To: Planning Commission
From: Jeff Churchill, AICP, Senior Planner, 425-556-2492
Date: January 9, 2013
Subject: **Redmond General Sewer Plan Amendment for Rose Hill Heights South**

Planning Commission Report

File Number: L120162, Rose Hill Heights South Sewer Plan Amendment

Planning Commission Recommendation: Do not approve the amendment.

Figure 1: Subject Area

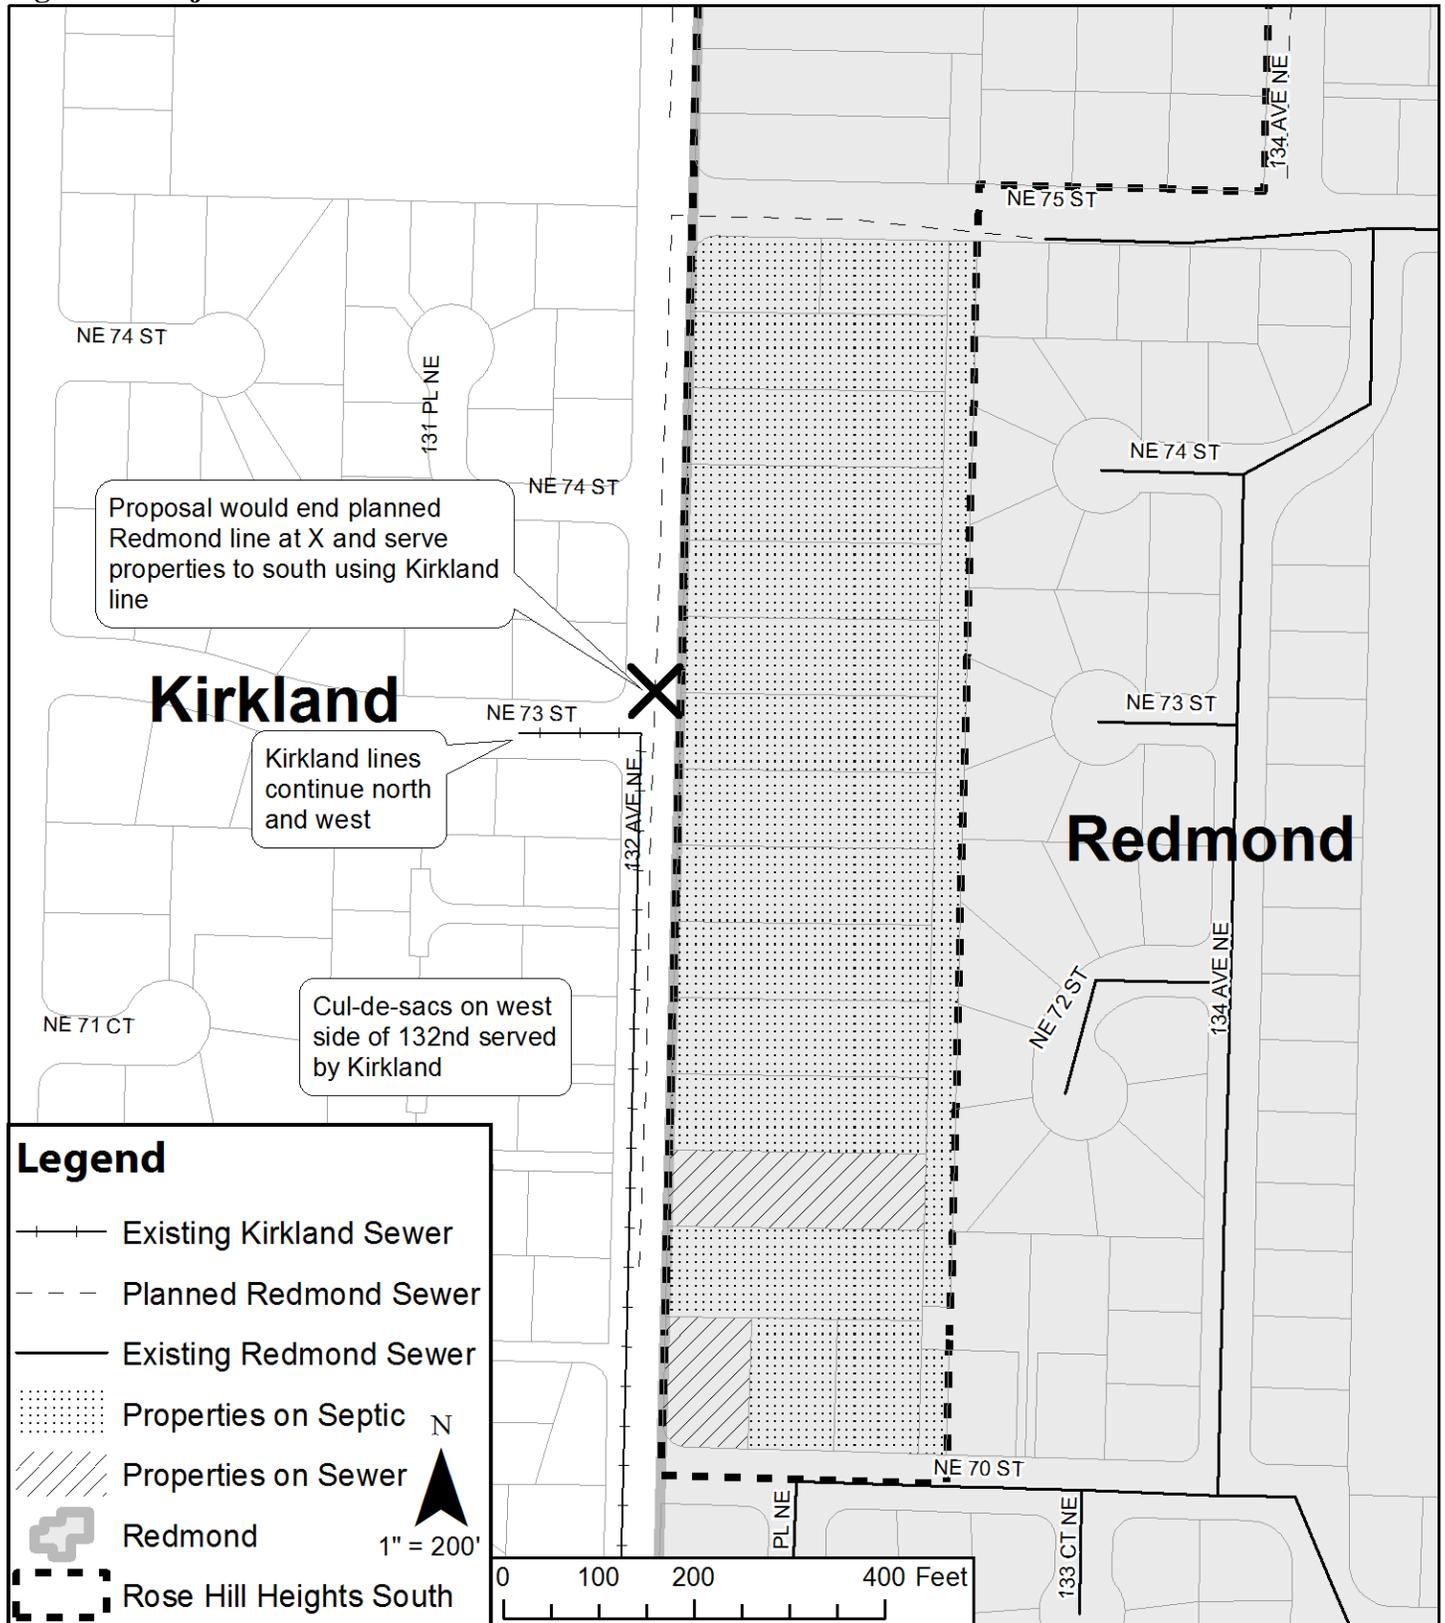
Summary: The Redmond General Sewer Plan describes existing facilities and needed system expansions and upgrades to serve projected growth over the next 20 years. Emerald Commercial II, LLC, represented by Yuval Sofer, proposes to amend a General Sewer Plan map for the Redmond-Kirkland Road Basin along 132nd Avenue NE. The Sewer Plan currently calls for the extension of a Redmond sewer main from the 13300 block of NE 75th Street west to the intersection with 132nd Avenue NE and then south along 132nd Avenue NE to NE 70th Street. The applicant proposes to amend the plan such that the planned extension

would end just north of two parcels that the applicant owns in the 7300 block of 132nd Avenue NE. Properties from there south would instead connect to a City of Kirkland sewer main in 132nd Avenue NE (see Figure 1 on next page).

- The proposal is inconsistent with Redmond’s sewer system design and service policies;
- The proposal would set precedent that would likely impede future implementation of the General Sewer Plan;
- The proposal would require that the City ultimately grant exceptions to its ordinary design standards in a situation where that is neither necessary nor desirable; and,
- The potential risks and costs associated with amending the General Sewer Plan exceed the potential benefits of amending the Plan.

Recommended Action: Adopt a motion denying approval of the proposed amendment.
